PACSB / XL / 109 ISSUE 1

FUEL PICKUP ASSEMBLY – LEADING EDGE TANKS

A.	<u>EFFECTIVITY</u>	<u>MODEL</u> 750XL	<u>S/N</u> 177, 186 up to and including 213, and 220
		750XL	8001 and 8002
B.	<u>REASON</u>	edge tank fue this part may	w of the installation of the wing leading el pickup assembly, it was found that have been installed pre-stressing the eb and/or the Pickup Assembly Pipe.
C.	DESCRIPTION		ection of the Wing Leading Edge Tank Pickup Assembly.
		Part B: Corre	ective actions (if necessary).
D.	<u>COMPLIANCE</u>	Within the next 165 flight hours, inspect and apply the correction actions (if necessary).	
		the same time	ecommended that this is completed at as Service Bulletin PAC/XL/099, if this ly been completed.
E.	APPROVAL	By delegated	authority.
F.	TOOLING	N/A.	
G.	WEIGHT AND BALANCE	No change.	
H.	REFERENCE	750XL Mainte	nance Manual.
I.	HOURS REQUIRED	Part A – 1 Hou Part B – 4 Hou	-
J.	WARRANTY COVER	Normal Warra	nty conditions apply.

FIGURE 1 INSPECTION AREA – LH WING VIEW (RH WING VIEW IS OPPOSITE SIDE)

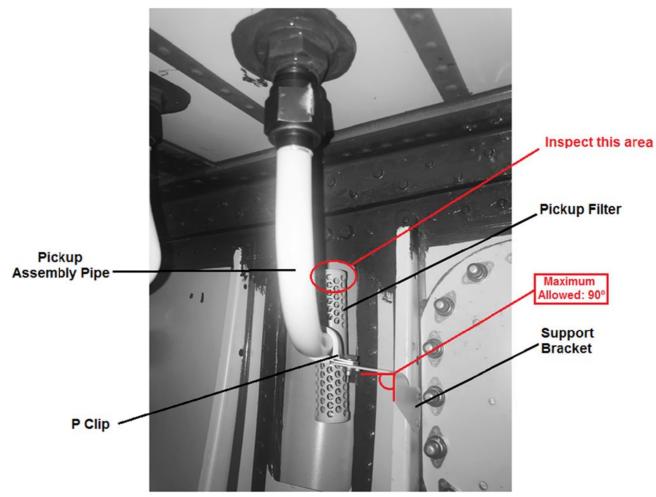
- 1) Drain the fuel from the wing tanks (Ref. 750XL MM, Chapters 12 and 28).
- 2) Remove the Wing Leading Edge Tank Fuel Caps.
- 3) Inspect the Support Bracket which connects the Pickup Assembly to the Wing Former (See Figure 1):

- If the angle of the Support Bracket is greater than 90°, this indicates that the flange of the bracket supporting the P Clip has been pulled aft and the Fuel Pickup assembly <u>is</u> likely under stress. Continue on Step 4).

- If the angle of the Support Bracket is 90°, this indicates that the Fuel Pickup assembly <u>is not</u> under stress, and then no further rectification action is required. Go to Step 10).

- 6) Loosen the screw attaching the P Clip to the Support Bracket and check (See Figure 1):
 - If the Pickup Assembly Pipe springs aft towards the wing spar (i.e. if the gap between the Pickup Filter and the edge of the Cutout is seen to decrease and there is a gap between the P Clip and the Support Bracket), then a corrective action will be required. Go to the Part B of this Service Bulletin.

- If no spring-back is observed and the P Clip can be reattached without stressing either the Pickup Assembly tube or the Attachment Bracket, then no further corrective action is required. Continue on Step 7).
